DEPARTMENT OF THE ARMY
WILMINGTON DISTRICT, CORPS OF ENGINEERS
69 DARLINGTON AVENUE
WILMINGTON, NORTH CAROLINA 28403-1343

Action ID. SAW-2009-00556
NC DOT TIP No.: I-5111/I-4739

Subject: MODIFICATION of 401 Water Quality Certification Pursuant to Section 401 of the Federal Clean Water Act and NEUSE BUFFER RULES, with ADDITIONAL CONDITIONS for Proposed widening of I-40 from I-440 to SR 1525 plus improvements to NC 42 and SR 1010 in Wake and Johnston Counties; Federal Aid Project No. IMNHF-040-4(139)301; State Project No. 42346.3.1; TIP Nos. I-5111 & I-4739. NCDWR Project No. 20190593 ver 7.

PROJECT REFERENCE NO.	SHEET NO.
1-5111/1-4739	17
R/W SHEET NO.	
ROADWAY DESIGN ENGINEER	HYDRAULICS ENGINEER
INCOMPLETE PLANS DO NOT USE FOR R/W ACQUISITION	
DOCUMENT NOT CONSIDERED FINAL UNLESS ALL SIGNATURES COMPLETED

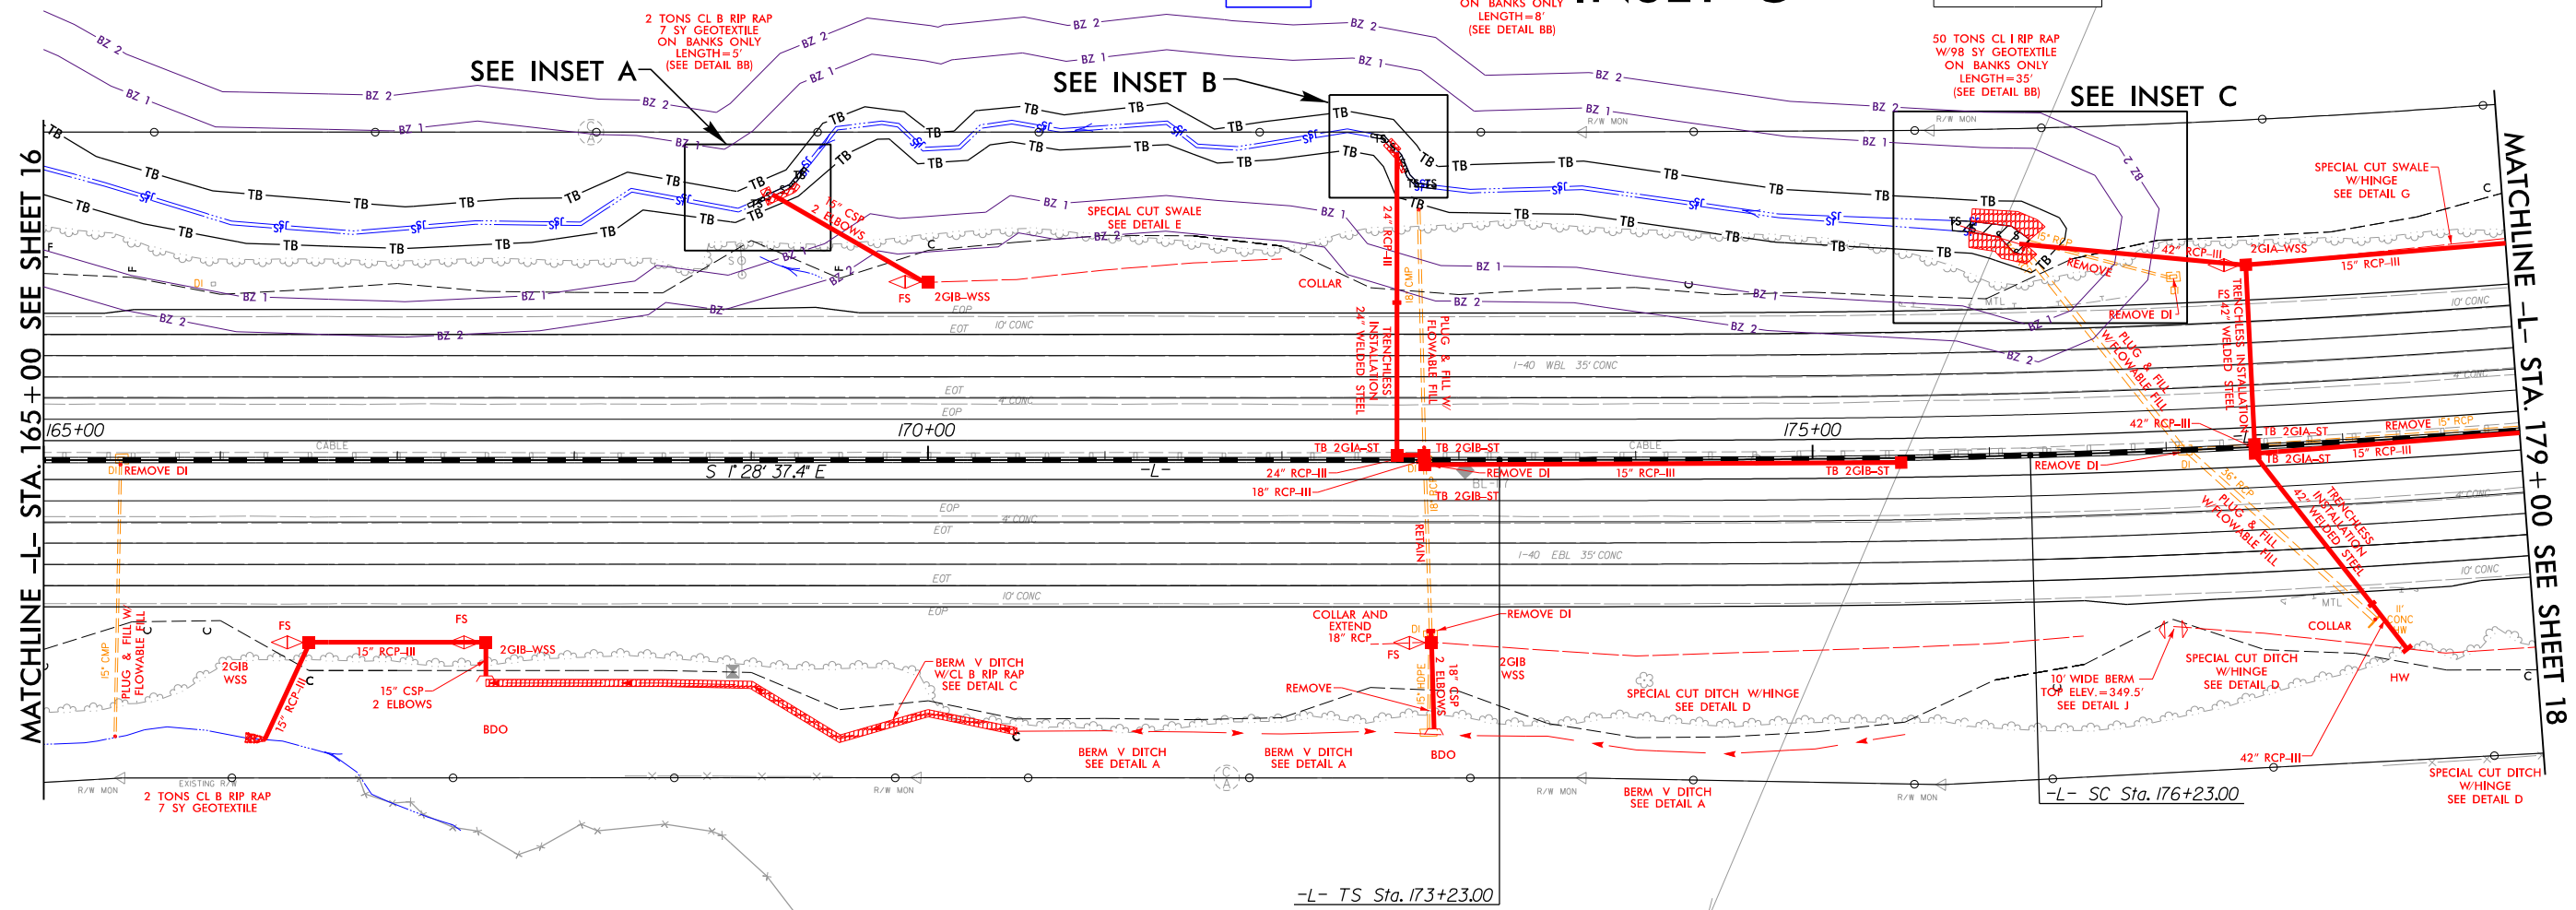
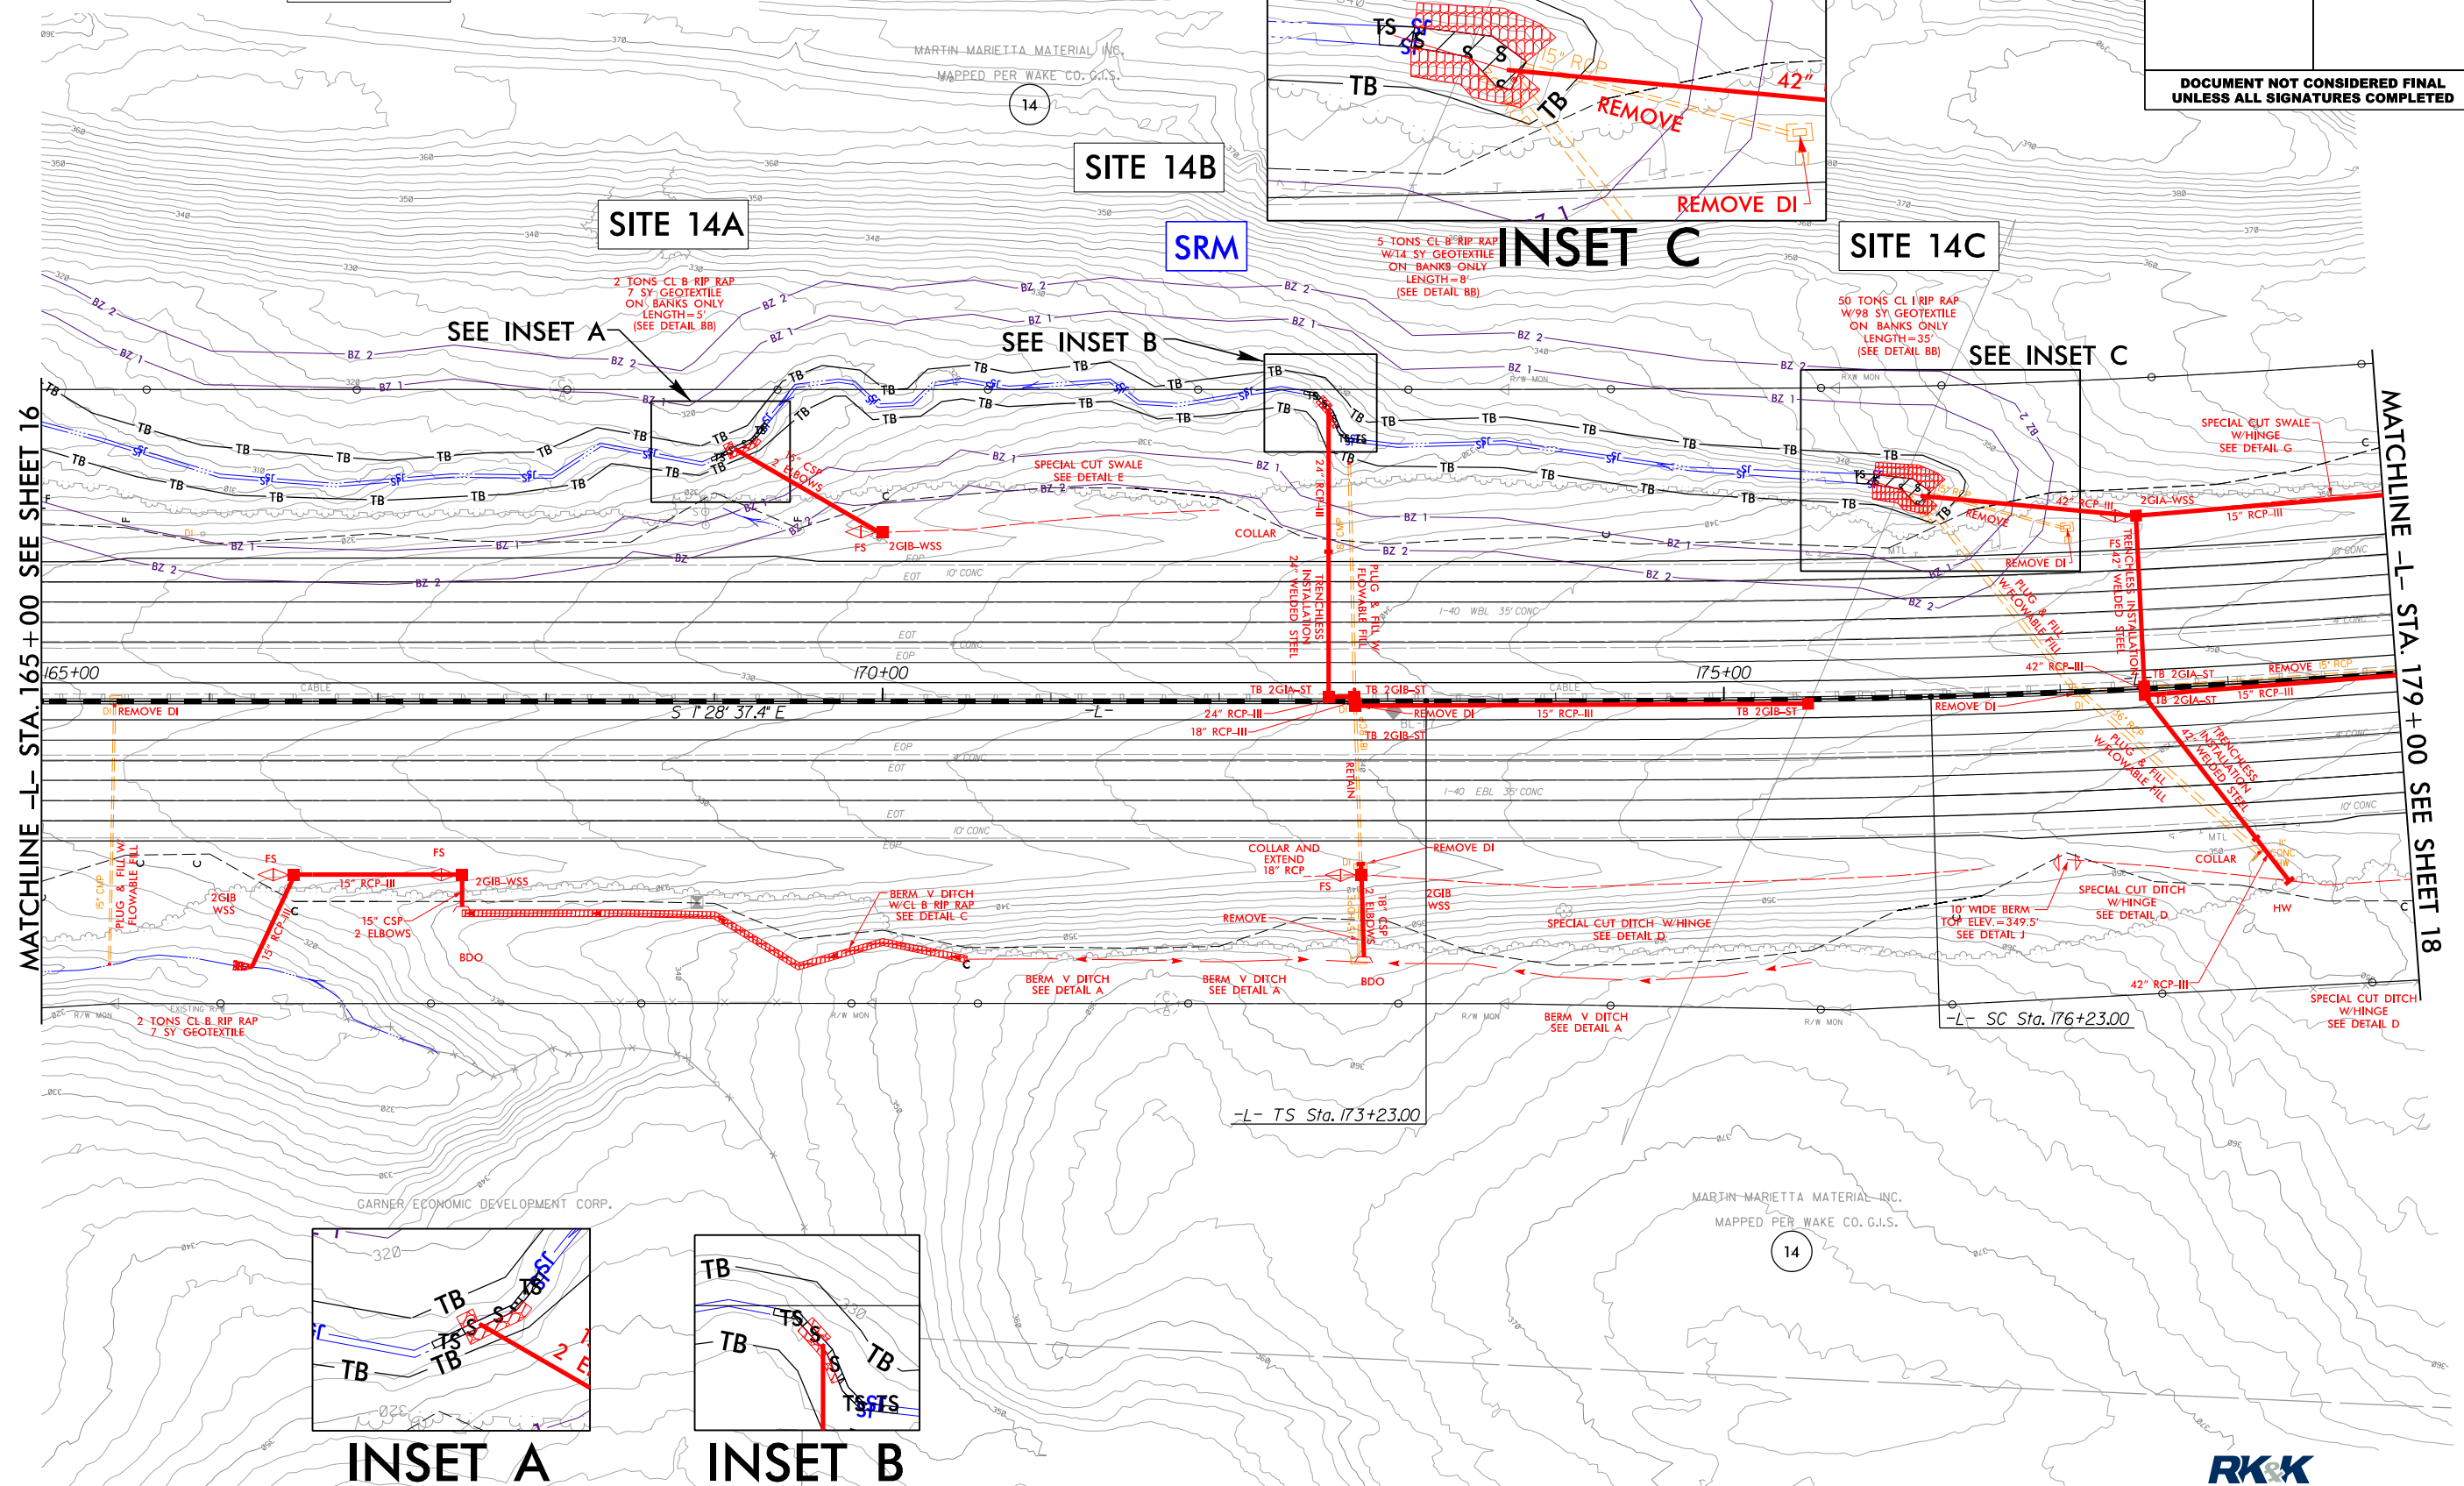
Site 14A: Additional bank stabilization is needed due to site conditions.

Site 14B: Additional bank stabilization is needed due to site conditions.

Site 14A:

- **+15 linear feet Stabilization permanent impact to Intermittent Stream**
 - **+400 square feet Zone 1 Buffer Mitigable Impact**
 - **+186 square feet Zone 2 Buffer Mitigable Impact**
- *Site 14A revised totals in application plan sheets July 6, 2022: 20 linear feet Permanent Stream Impact. 20 linear feet Temporary Stream Impact. 0 ac wetland impact. 2058 square feet Zone 1 Mitigable Buffer Impact. 1132 square feet Zone 2 Mitigable Buffer Impact.*

Site 14B:

- **+12 linear feet Stabilization permanent impact to Intermittent Stream**
 - **-12 linear feet (decrease) Temporary intermittent stream impact**
- *Site 14B revised totals in application plan sheets July 6, 2022: 20 linear feet Permanent Stream Impact. 31 linear feet Temporary Stream Impact. 0 ac wetland impact. 1824 square feet Zone 1 Mitigable Buffer Impact. 1680 square feet Zone 2 Mitigable Buffer Impact.*

The authorized work shall be completed in accordance with the attached revised permit drawings sheets 17 and 49 of 125 submitted on July 6, 2022, and the Wetland and Surface Water Impact Summary Sheets 122 and 125 of 125 submitted on July 6, 2022. As there are an additional 40 linear feet of permanent stream impacts, compensatory mitigation is required at a 2:1 ratio for the permanent stream impacts associated with this modification. As proposed in the modification request, compensatory mitigation must be completed by debiting an additional 80 linear feet of compensatory stream mitigation credits from the official ledger for NCDOT's Marks Creek Mitigation Site in Wake County.
